Re: Nobscot Scout Reservation Trail Project
1 Nobscot Road, Sudbury, MA

Howard Stein Hudson (HSH) has prepared a response to the Sudbury Conservation Commission comments dated August 22, 2022 and offers the following responses including submitting supplemental information:

SITE PLAN FOR NOBSCOT SCOUT RESERVATION TRAIL PROJECT SUDBURY AND FRAMINGHAM, MA.

NOBSCOT SCOUT RESERVATION PERMITTING & CONSTRUCTION PLANS						
HSH PROJECT NUMBER	DATE	DRAWN BY	CHKD. BY	APPRVD. BY	SHEET NO.	TOTAL SHEETS
2016033.02	10/24/22	JBC	JD	REL	8	22

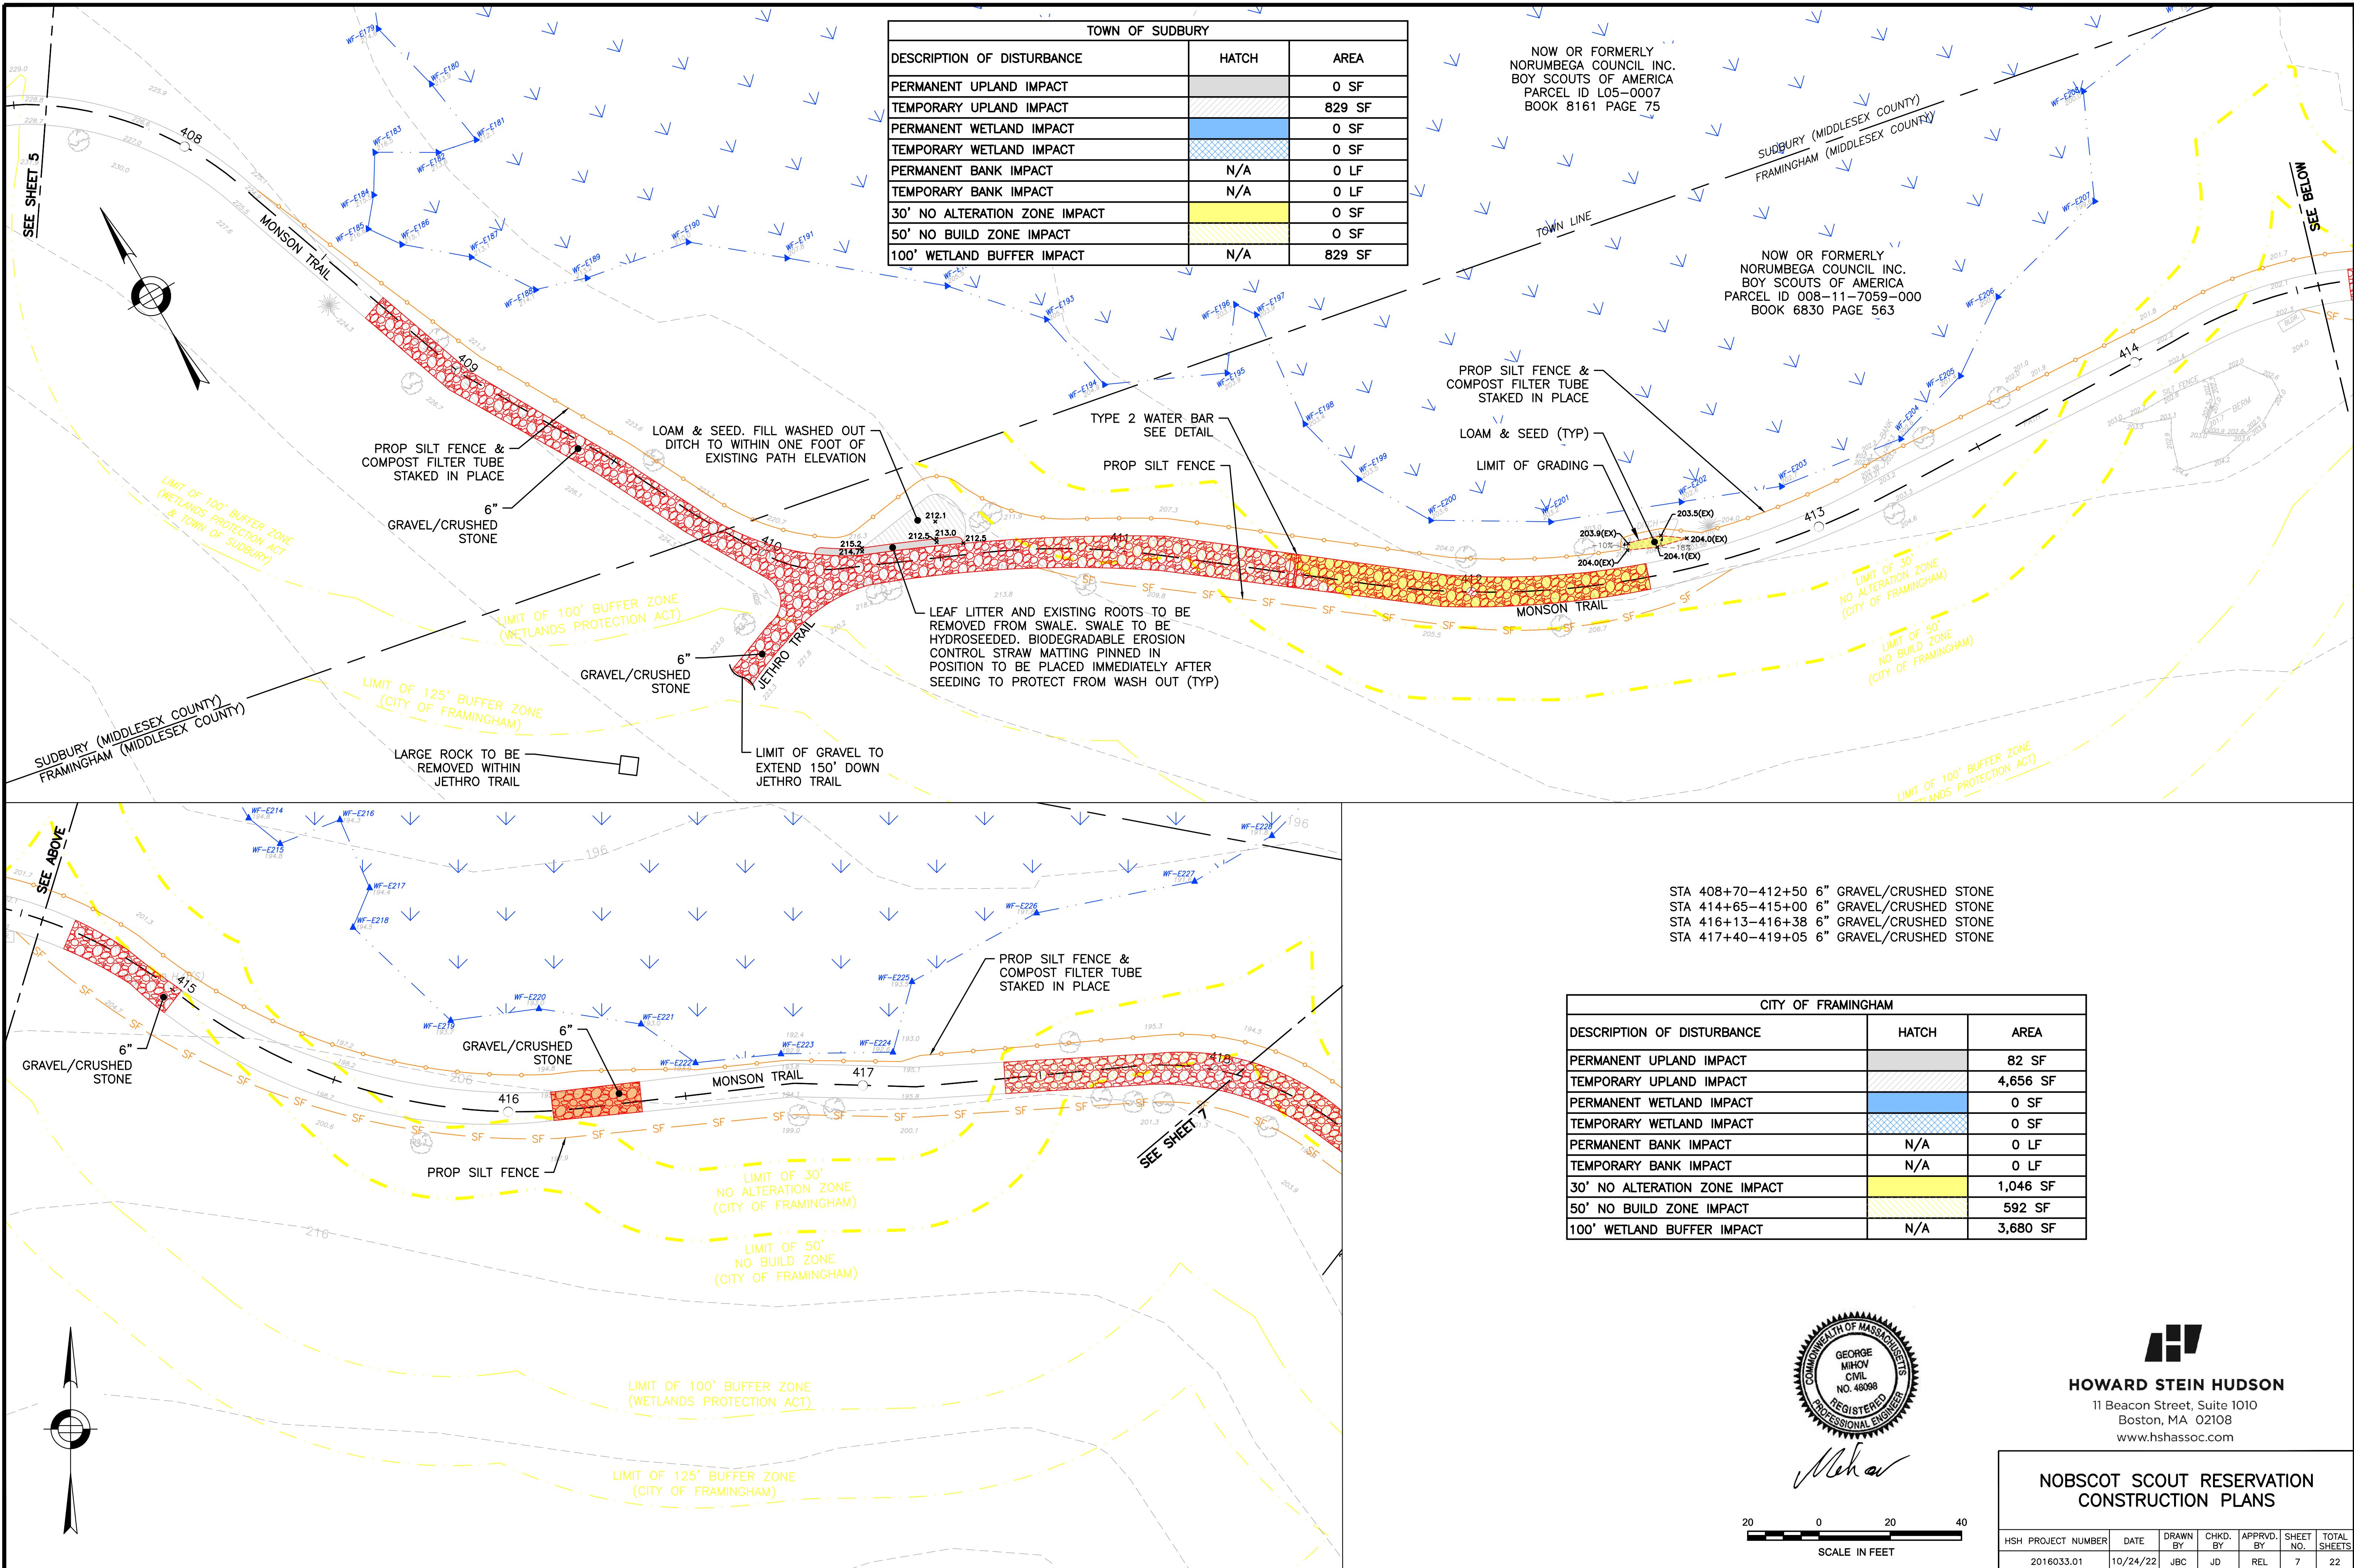
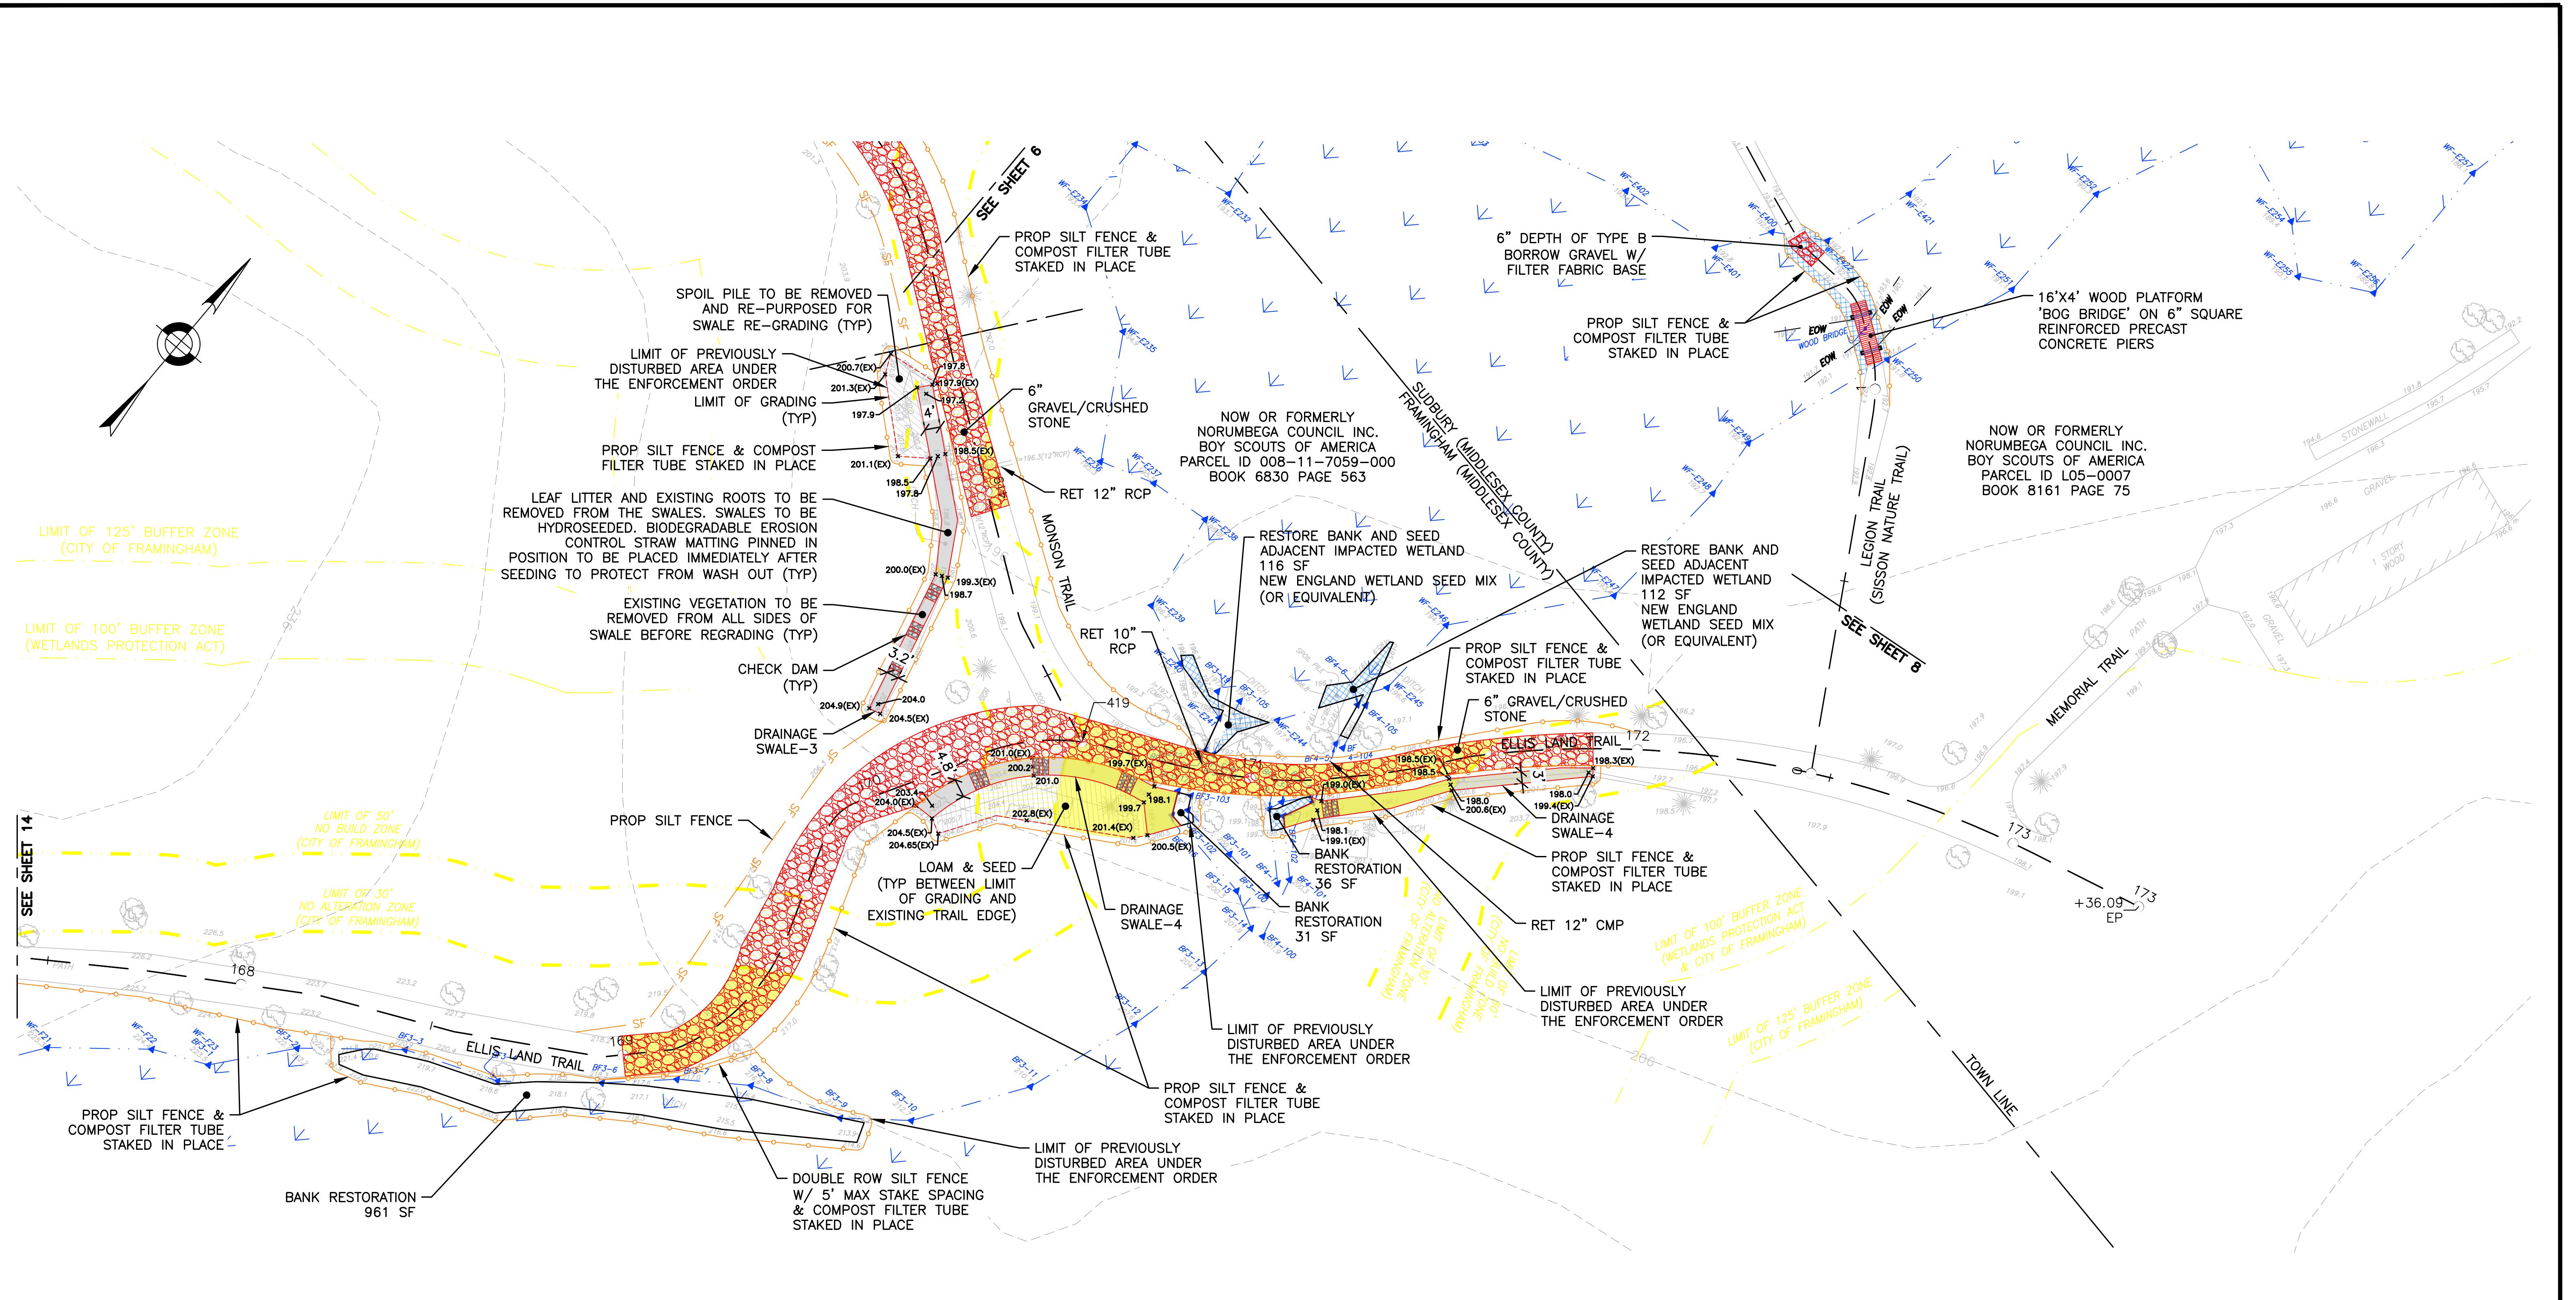
Comment 10: *Sheet 8 shows the silt fence being installed through the wetland with no wetland impact noted. The applicant should explain why the fence is positioned where proposed and identify any wetland impacts for this area. Ultimately the silt fence should be repositioned outside the wetland area.*

Comment 12: *Trail work at the boundary between Sheets 8 and 9 shown on the plan sheet above has no erosion controls and results in wetland fill. The applicant should explain if this area of trail could be moved to prevent this fill.*

Response: **The silt fence is positioned to created a work zone to construct bog bridges. The area between the silt fence and existing edge of trail will be loamed ad hydroseeded after the bridge is installation. This area has been labelled as a temporary wetland impact.**

Response: **This area has been redesign. There will be no filling of the wetland in this area. Ersion control measure have been added to the plan set on page 8 & 9.**
